Report of the Technical Consulting Team to the Pinelands Commission

regarding
"Comprehensive Plan for
Wireless Communications Facilities in the Pinelands"

August 17, 1998

A Special Report to the Pinelands Commission

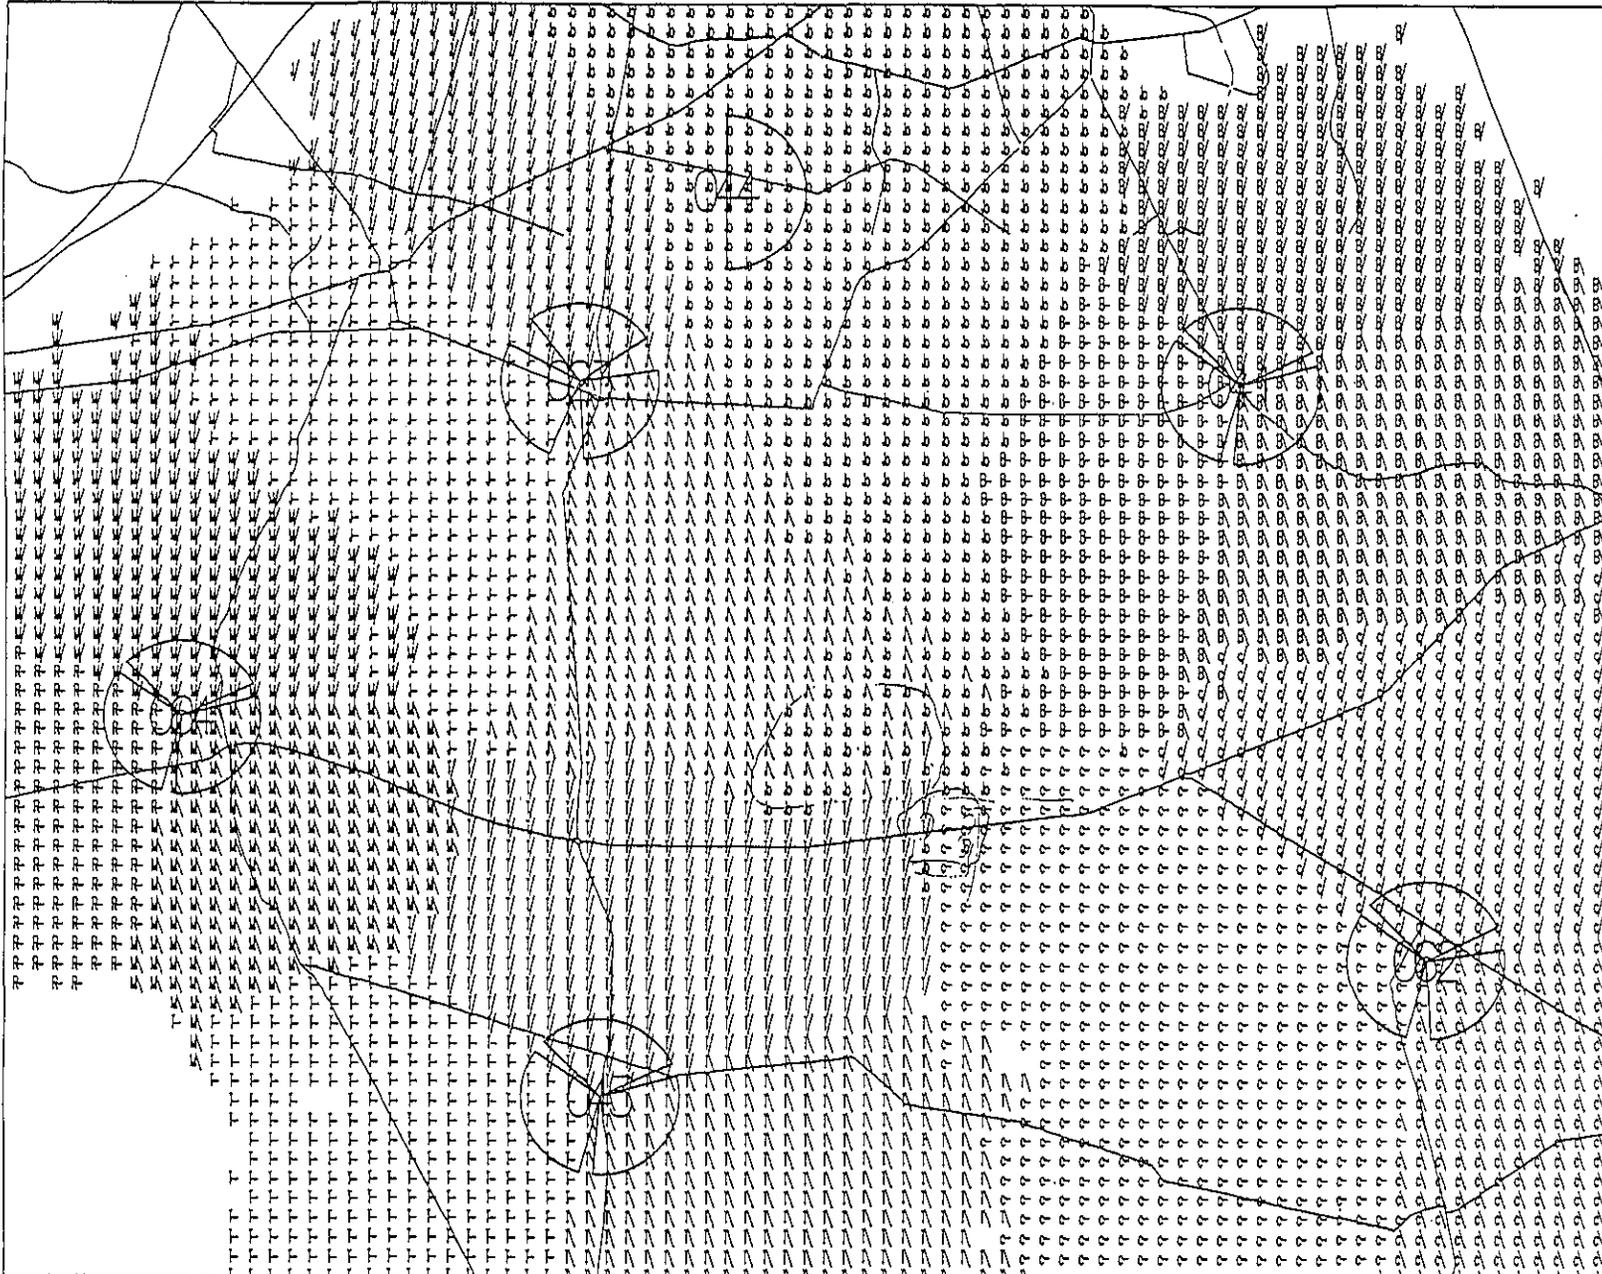
3.2 Plot 7-A shows the current relevant RF radiation levels. There is a “low power” section of about six miles along Rt. 70, east of the intersection between Rts. 70 & 206. Along this section, low received power (between -85 dBm and -95 dBm) is predicted, under the usual assumptions regarding radio equipment in standard vehicles.

PINELAND
 PROPOSED

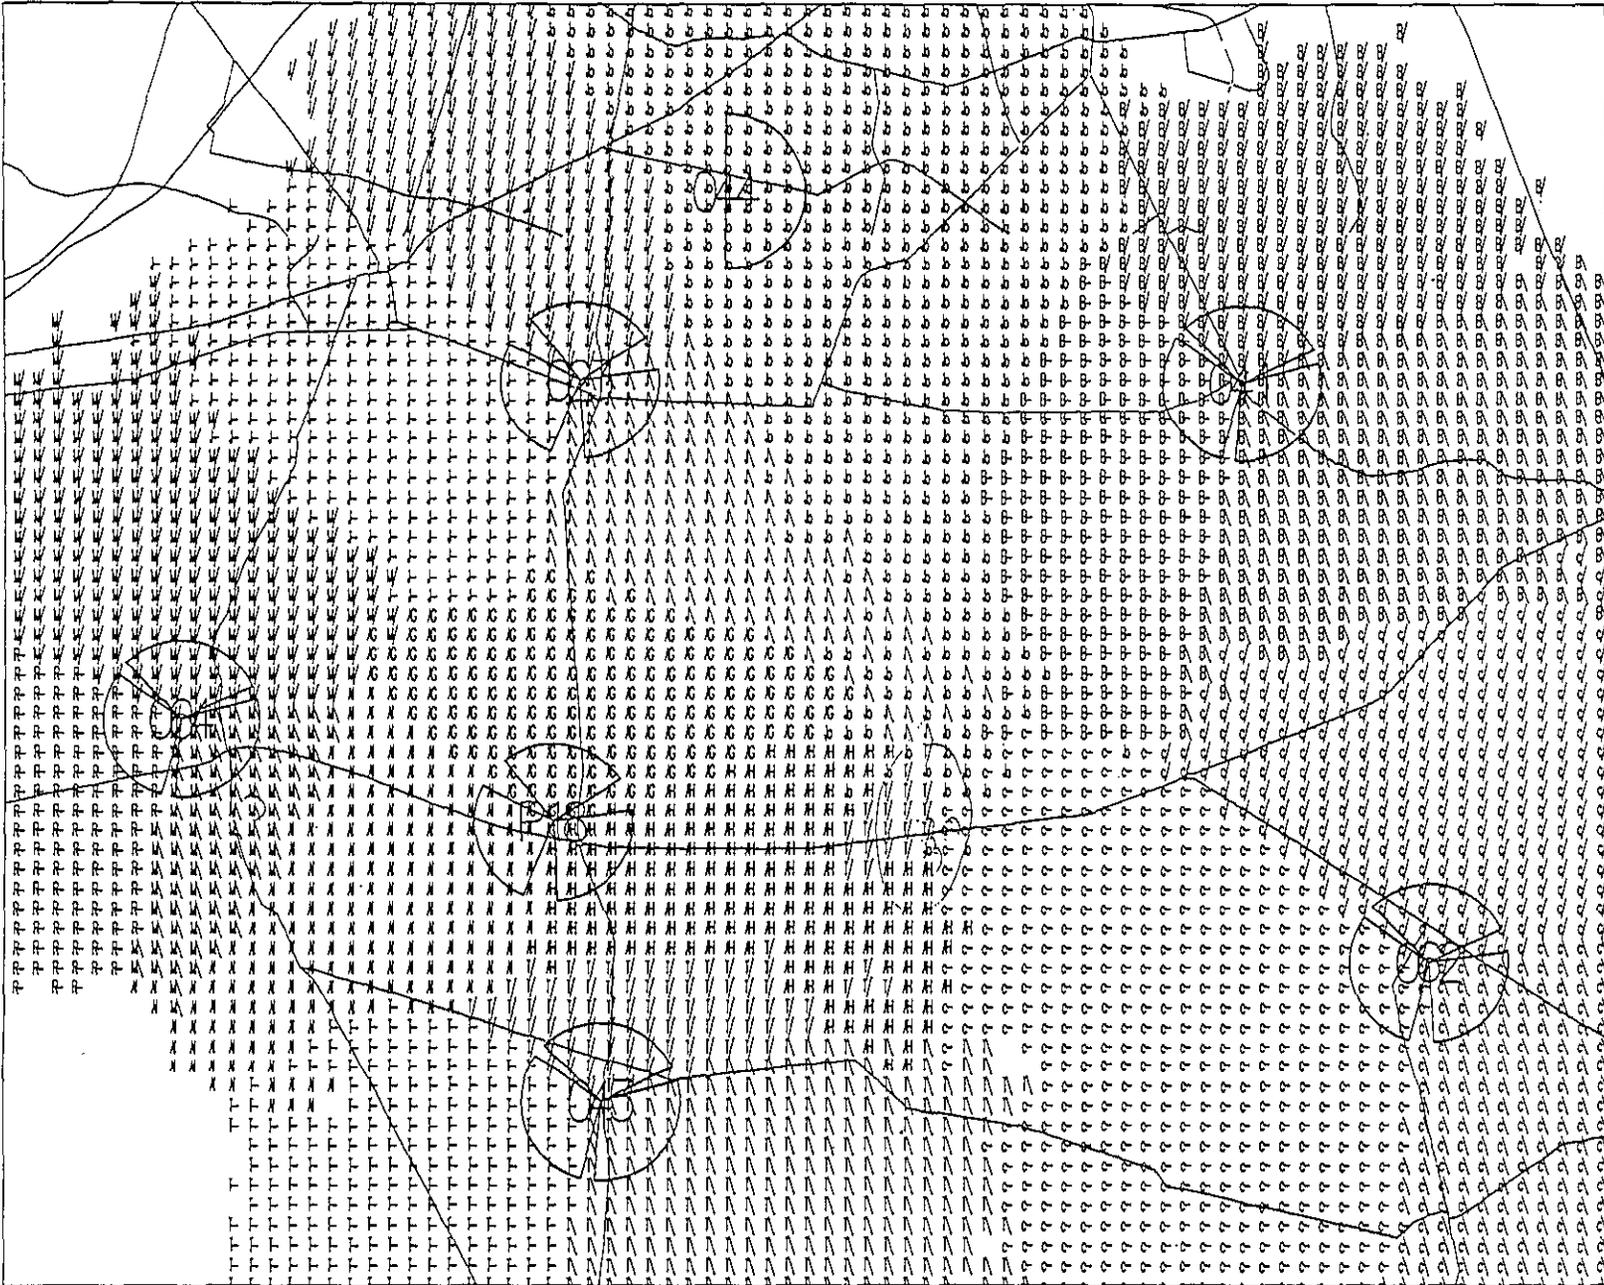
3.3 Plot 7-B shows what the situation would be if the CT’s Sept, ‘97 recommendation were implemented. The stretch of low power is reduced by 2 miles. The reduction is in the *western* part of the present low-power section, immediately to the east of the 70/206 intersection.

BAMS Plymouth Meeting
 BAMS OC-Philly
 Best Server
 CellCAD II v4.2 *BELL*
 WOODLAND *1RoPos2D*

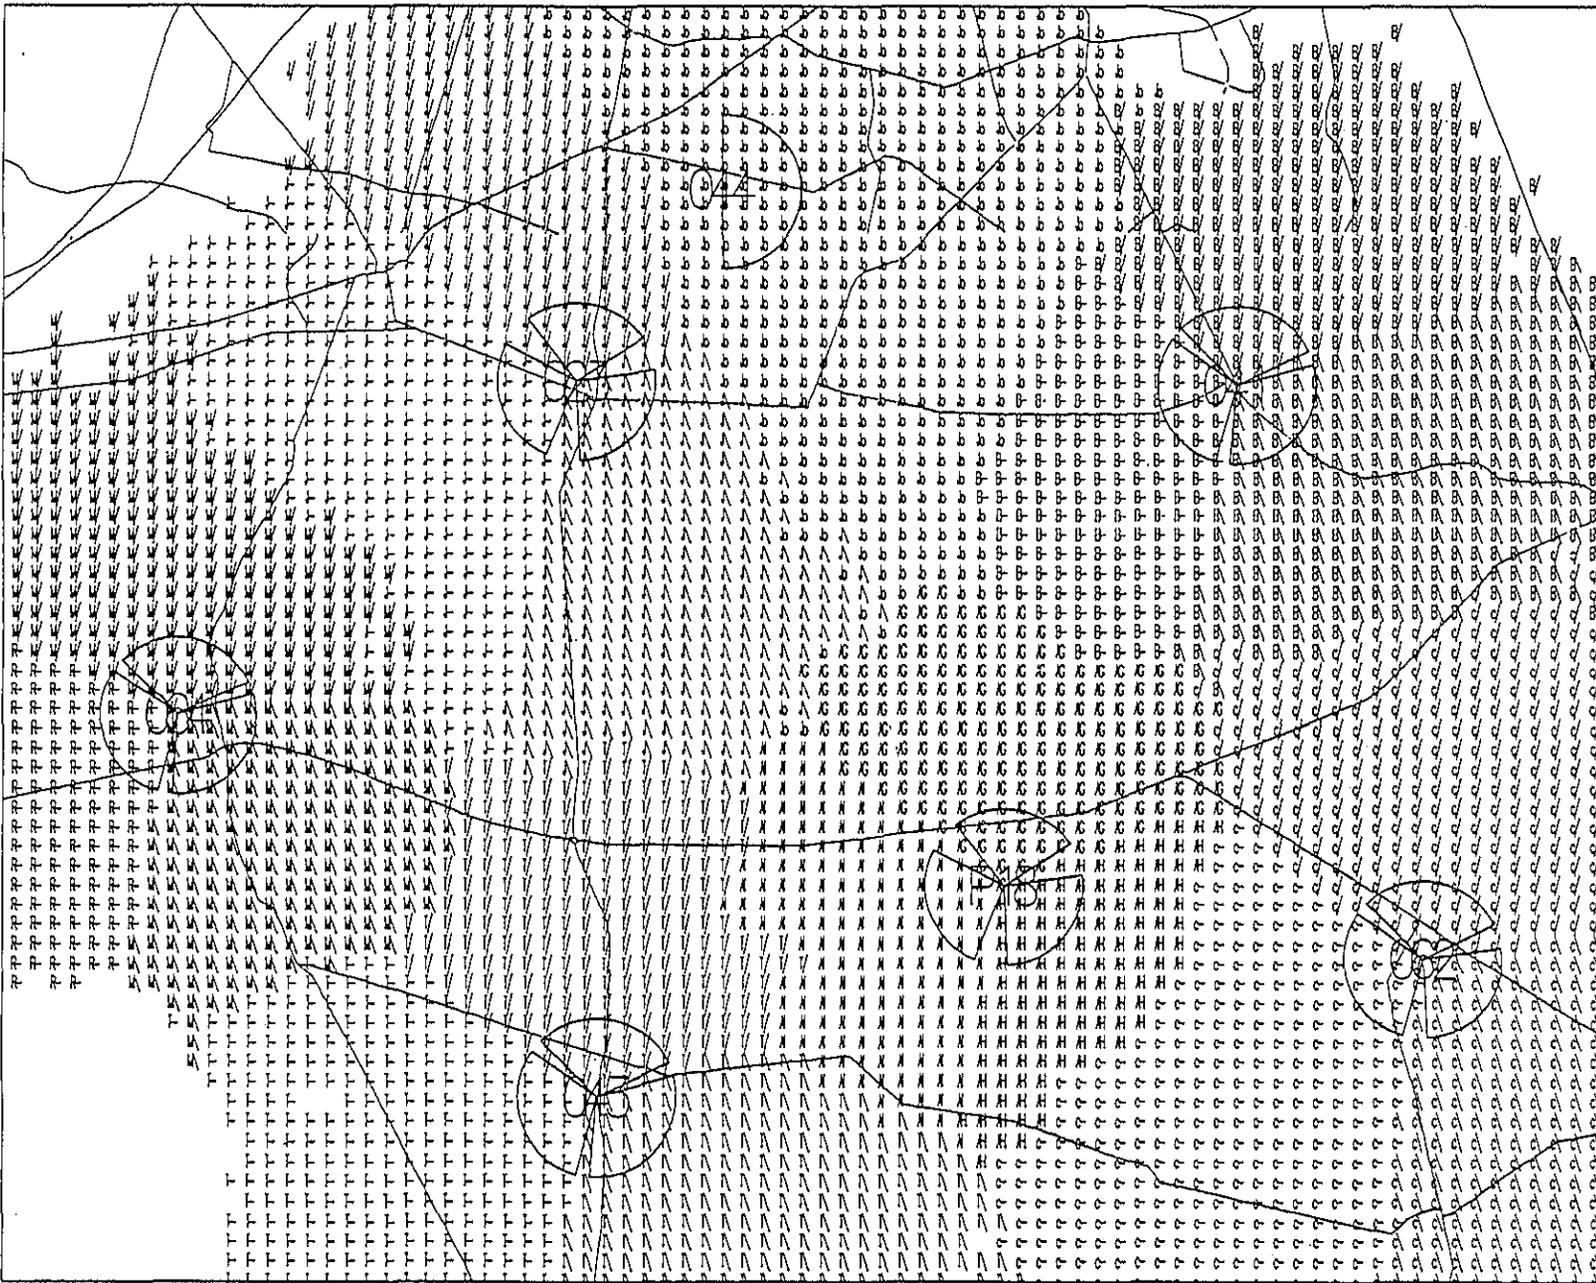
3.4 Plot 7-C shows BAMS recommendation – the stretch of low power is reduced by 5.5 miles in the *eastern* part of the present section of low power.

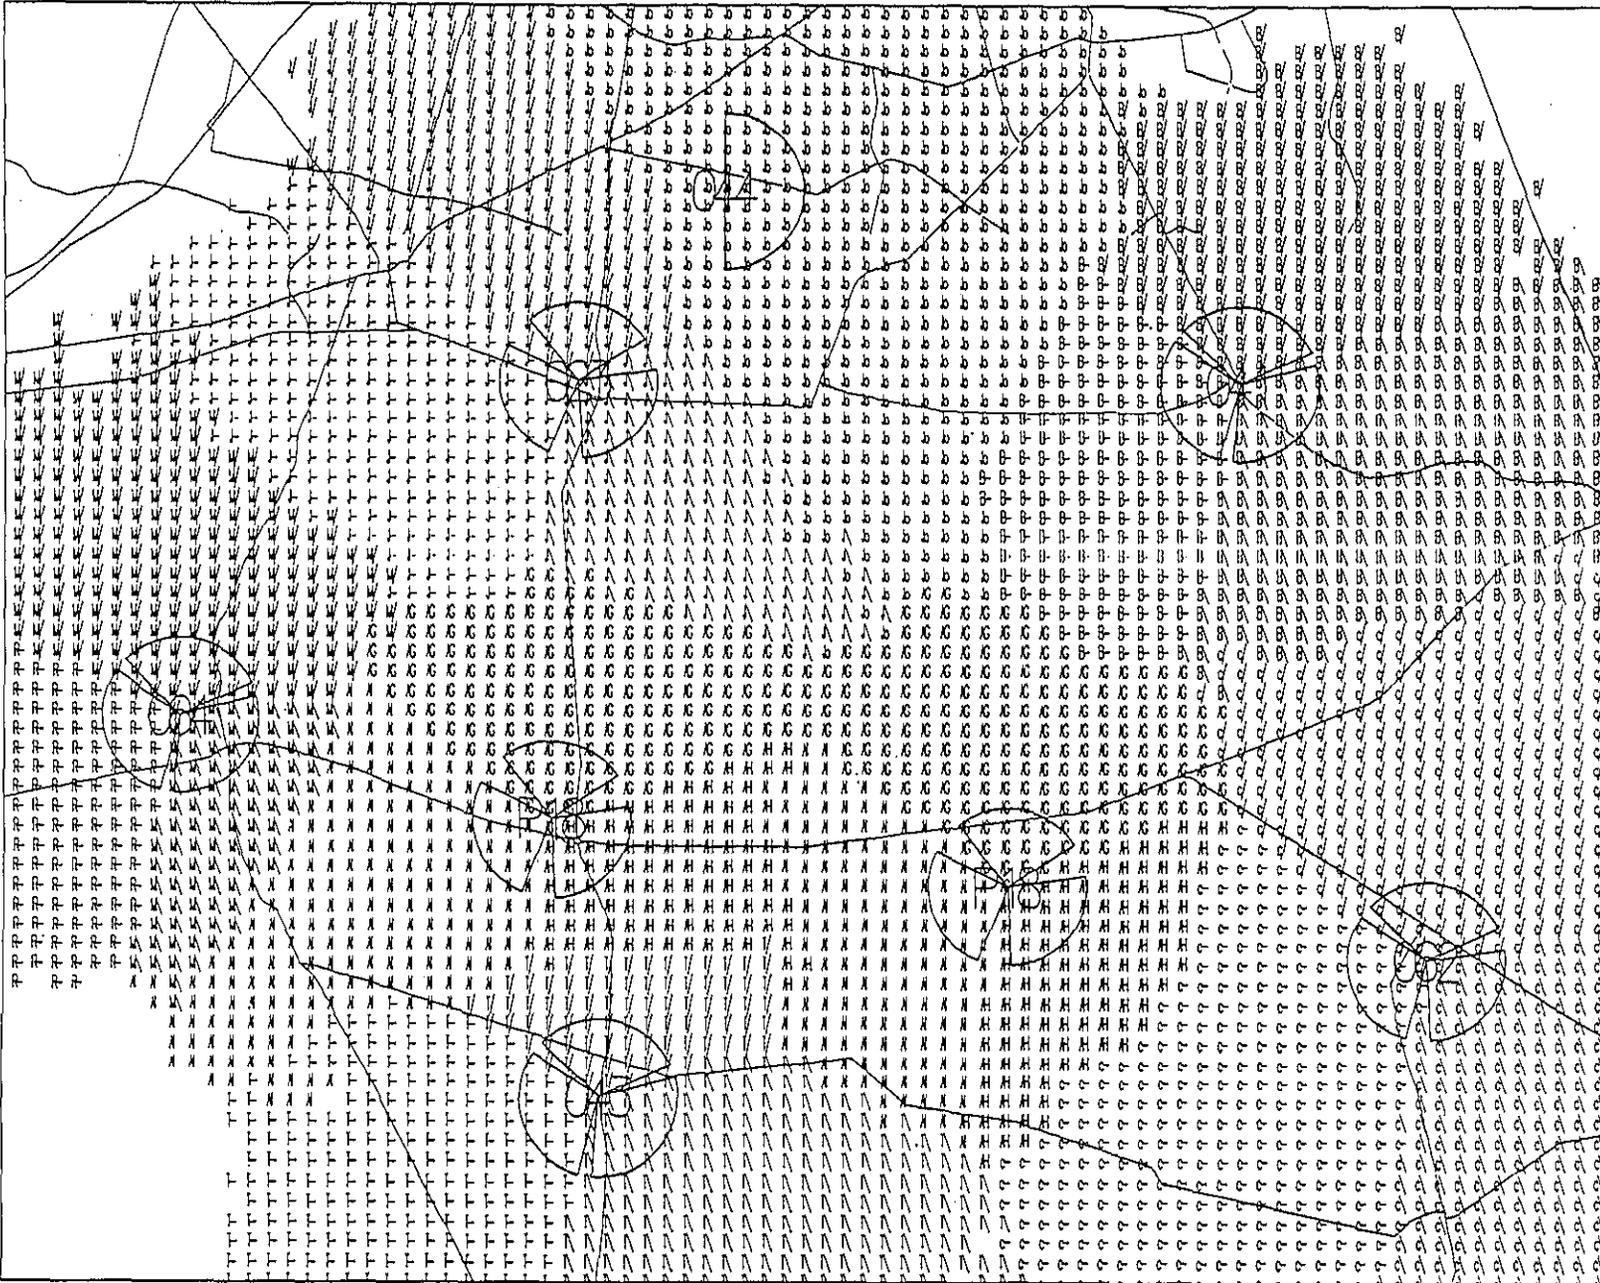
3.5 Plot 7-D shows the BAMS plan enhanced by the CT suggestion that an antenna be used at the 70/206 intersection. Under this configuration, the whole low-power section along Rt. 70 is brought to acceptable levels of service (greater than -85 dBm).
